**PETITION FOR VARIANCE
APPLICATION**

Name of Owner Marshal Gorwitz, President United Apartments, Inc., Manager for:	Project Description 45 Unit, 3 Story Apartment Building (R-2) with Underground Parking Paragon Place at Bear Claw Way Building 4 Project #: BLDNCC-2020-05090	Agent, architect, or engineering firm Schuler & Associates, Inc.
Company (if applies) Paragon Place at Bear Claw Way LLC	Tenant name (if any)	No. & Street 2711 N. Mason Street, Suite F
No. & Street 660 W. Ridgeview Drive	Building Address 9604 Wilrich Street	City, State, Zip Code Appleton, WI 54914
City, State, Zip Code Appleton, WI 54911	Phone 920-734-9107	Name of Contact Person Jeffrey Rustick
Phone 920-968-8107	e-mail jtr@schulerassociates.net	
e-mail mgorwitz@ufgroup.net

PETITION FOR VARIANCE APPLICATION ATTACHMENT

VARIANCE REQUEST EXHIBIT

EXHIBIT

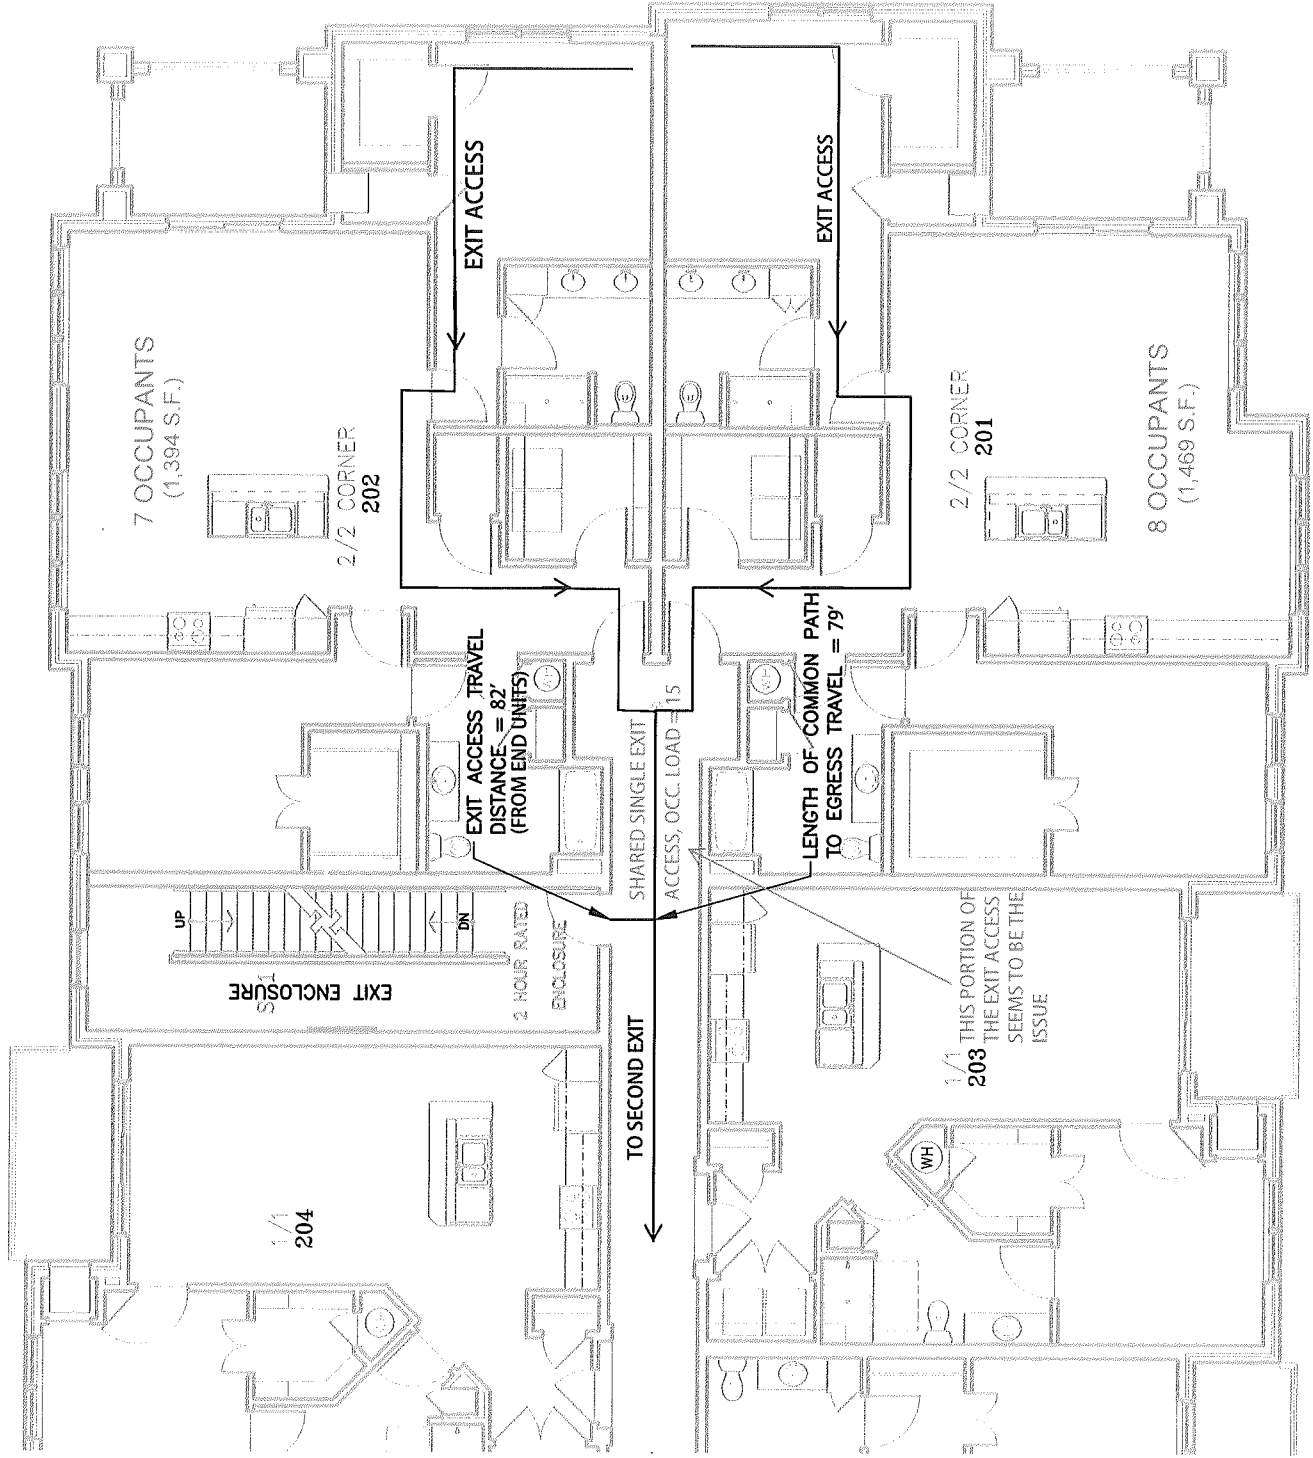
It should be noted that just because the corridor in question is a code complying corridor and not otherwise considered a dead end corridor for occupants entering the corridor does not relieve the applicability of the single means of egress "space" provisions of Table 1006.2.1. The aggregate occupant load from adjoining rooms must be added to verify all converging occupants into a given space are provided the adequate number of means of egress. The attached diagram, in my opinion, appears to comply with the intent of the code.

If you have two R-2 dwelling units with a combined occupant load of 20 or less, can the provisions of Section 1006.2.1, Exception 1 be applied or does the increased occupant load need to be in only one dwelling unit? The proposed R-2 building will have an automatic sprinkler per Section 903.3.1.1 and the lengths of the common paths of egress travel will be met. Reading “Significant Changes to the International Building Code, 2018 Edition” where an occupant load of 20 is allowed in this situation without an exception needed, I am led to believe that it was also allowed in 2015 IBC, while using the exception. The attached drawing shows the situation and the bottom line question is whether the exiting shown on attached drawing complies with 2015 IBC Section 1006.2.1 utilizing Exception 1? Thank you.
